## PLANNING & ZONING COMMISSION

RE: Staff Review of the Preliminary Site Plan for Mulberry Knoll Associates, LLC, (C/Z 2037) for the establishment of a shopping center to contain 663,213 square feet of commercial improvements within (23) proposed structures, a fuel station, commercial drive-through facilities, internal roads, parking, sidewalks, landscaping, stormwater management, and associated site improvements on two parcels comprised of 73.457 +/- acres to be located on the northwest side of John J. Williams Highway (Route 24) approximately 400 feet south of Plantation Road (S.C.R. 275 / Route 1D) and the northwest corner of Mulberry Knoll Road (S.C.R. 284) in Rehoboth Beach, Delaware.  
Tax Parcels: 334-12.00-46.00 and 334-12.00-47.00

Staff have reviewed the submitted Preliminary Site Plan for compliance with Chapter 115 (the Zoning Ordinance) and the Planned Commercial (C-4) District Site Plan specific criteria outlined in §115-

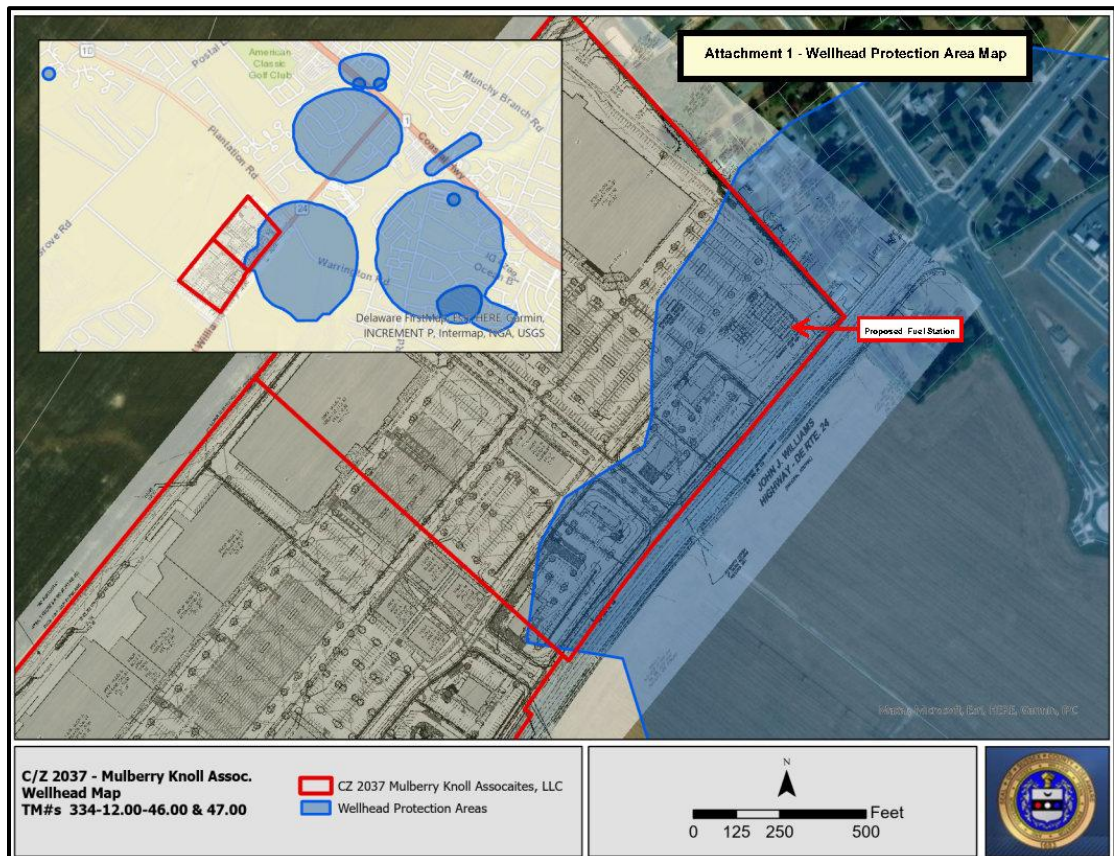
2. Staff note the Wellhead Protection Area across the southeastern portion of Parcel #46.00. (Attachment 1) Please note, any plan submitted for review will need to meet requirements of §89-6(F)) relating to impervious quotients and source water protection. Fueling stations appear to be proposed within the extent of the wellhead zone. Staff note that any underground storage tanks will be required to meet all the applicable regulations of the State of Delaware (§89-6(F)(6)). Staff request that this is responded to prior to the public hearing.

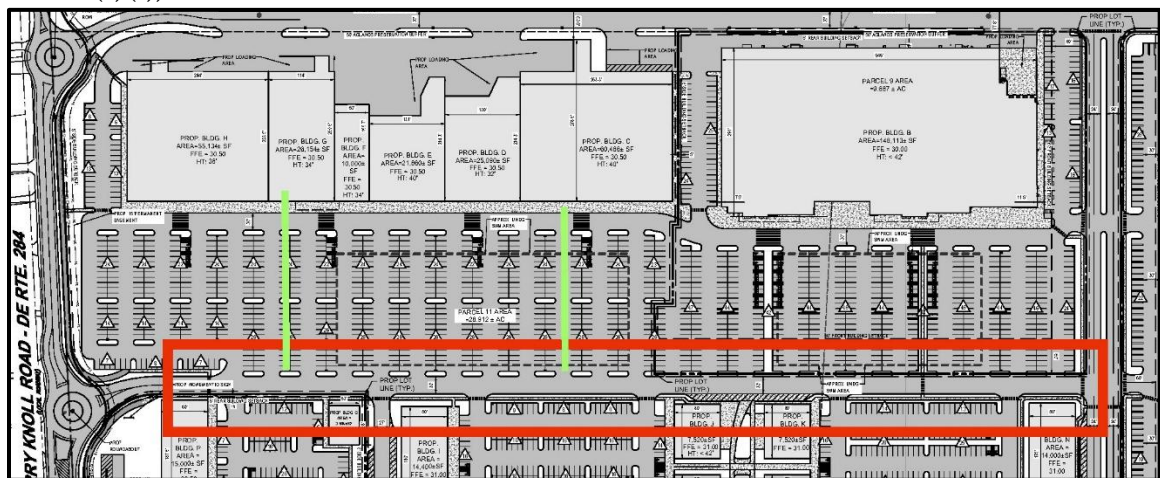
14. Staff recommend sidewalks be provided on both sides of all 3 primary internal circulation routes. Specifically, the Plan would benefit from sidewalks on the north side of the road corridor (Pictured in red). running between the largest parking areas in front of Buildings “B & (C-H) and proposed “P, I, J, K, and N” immediately to the south. Additionally, staff recommend pedestrian sidewalk corridors be provided to connect the frontage of Proposed “Buildings C-H” southward to this corridor as well (Pictured in green) (§115-83.24) & (§ 115-83.25F(4)(a)).

Staff note that a landscaped divider to separate directions of traffic, similar to the one provided within the primary circulation road between the proposed “Building A” and “Buildings B&N” could benefit the plan’s pedestrian design.

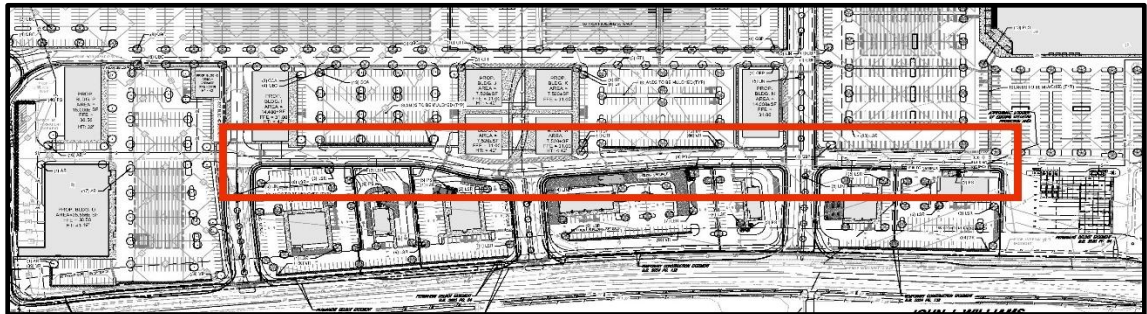
4. Street trees and shade trees within existing parking lots are encouraged to lessen the intensity of large parking areas (Sussex County Comprehensive Plan, 12-12). Staff recommend a robust street tree design along the primary lateral corridors of internal vehicle and pedestrian circulation in order to enhance the pedestrian design on the site. Staff recommend the inclusion of more street trees along the southern most primary circulation corridor parallel to Route 24 (Pictured in red) (§115-83.24) (§115-83.25F(4)(a)).
